UNITED STATES PATENT AND TRADEMARK OFFICE

Office Action Summary	Application No. 10/559,611	Applicant(s) OSSBAHR, GILBERT	
	Examiner NAHID AMIRI	Art Unit 3679

DETAILED ACTION

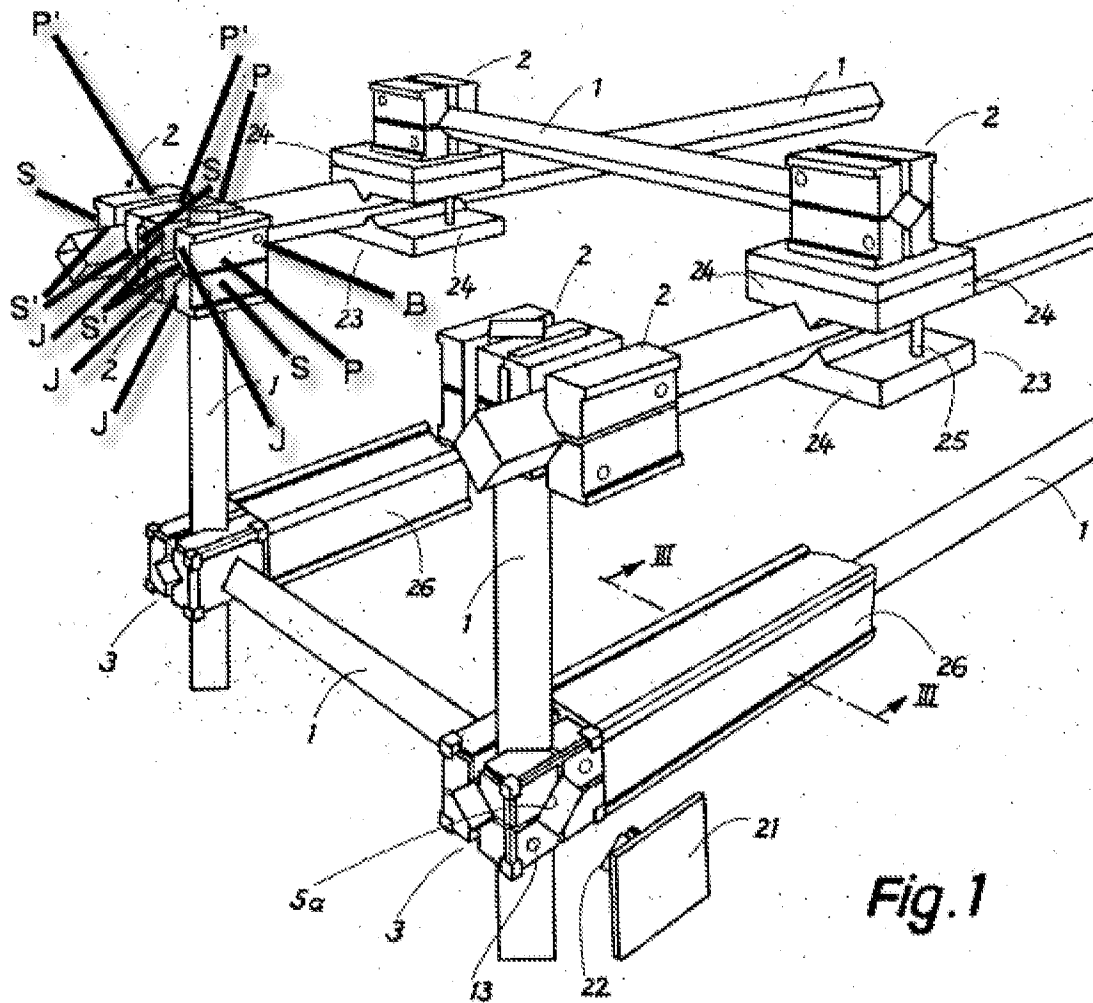
With respect to claim 1, Neff et al. disclose a system (Fig. 1) for detachable joining of at least first and second beams (1) of rectangular cross-section comprising for each said first beam (1) to be joined, a first pair of fixing plates (P) mountable on opposite sides of a said first beam (1) and fixable along said first beam by friction maintained by tightening bolts (B), each one of the fixing plates (P) comprising an inner planar surface (S') adapted to face said first beam (1), and an outer planar surface (S), which in adapted to face away from said first beam (1), for said second beam (1) to be joined, a second pair of fixing plates (P') mountable on opposite sides of said second beam (1) and fixable along said second beam by friction maintained by tightening bolts, each one of the fixing plates (P') comprising an inner planar surface (S') adapted to face said second beam (1), and an outer planar surface (S), which is adapted to face away from said second beam (1), the outer planar surface of said first pair of fixing plates (P) being bearable against the outer planar surface of said second pair of fixing plates (P') when said first and second beams (1) are arranged to be joined in perpendicular or parallel directions, the relative

positions of said first and second pairs of fixing plates (P, P') being fixed by locking elements (constituted by nuts not shown) in recesses in said outer surfaces of the said first and second fixing plates (P, P') said locking elements also anchoring the tightening bolts (B).

Neff fails to disclose the inner planar surfaces of the first and second pair of fixing plates are parallel to the outer planar surfaces of the first and second pair of the fixing plates. There is no criticality is associated with the inner and outer planar surfaces being parallel to one another, since one would know to use this type of system for square, rectangular and/or any other shape beam. Therefore, it would have been an obvious matter of design choice to have the two inner and outer planar surfaces of the fixing plates of Neff being parallel to one another fence since such choice appears to be no more preference which they are known.

With respect to claim 3, Neff et al. disclose (Fig. 1) that the each fixing plate (P, P') comprises projections (J) arranged at each corners of the fixing plate (P, P').

With respect to claim 8, Neff et al. disclose a detachable beam joint system (Fig. 1) comprising a plurality of beams (1) of rectangular cross section, each beam (1) having at least one pair of fixing plates (P) mounted on opposite sides of the respective beam (1) and fixable along the respective beam by friction maintained by tightening bolts (B), each one of the fixing plates (P) comprising an inner surface (S') facing the respective beam (1), and an outer surface

(S) to said inner surface (S') and which faces away from the respective beam (1), the outer surfaces of each pair of fixing plates (P) being bearable against one of the outer surfaces (S) of another pair of fixing plates (P') mounted on opposite sides of another beam (1) when respective beams (1) are arranged to be joined in perpendicular or parallel direction, whereby every surface of every beam (1) is either parallel or orthogonal to every other surface, the relative positions of said pairs of fixing plates (P) being fixed by locking elements (constituted by nuts not shown) in recesses in the outer surfaces of the respective fixing plates, said locking elements also anchoring the tightening bolts (B); and wherein the cross sectional dimensions of all beams (1) are module or a multiple thereof.

With respect to claims 9, 10 and 14, Neff discloses (Fig. 1) that the cross sectional dimensions of all beams (1) are modules; and a beam is comprised of a composite plurality of beams of cross sectional dimension a multiple thereof as much as Applicant's invention is.

With respect to claim 11, Neff discloses (Fig. 1) that each of said first beam (1) and said second beam (1) has an additional pair of fixing plates (P') mountable on opposite sides of said beam (1) and fixable along said beam (1) by friction maintained by tightening bolts (B), each one of the fixing plates (P') comprising an inner surface adapted to face said beam (1).

With respect to claim 13, Neff discloses (Fig. 1) that the additional beams (1) of rectangular cross section.
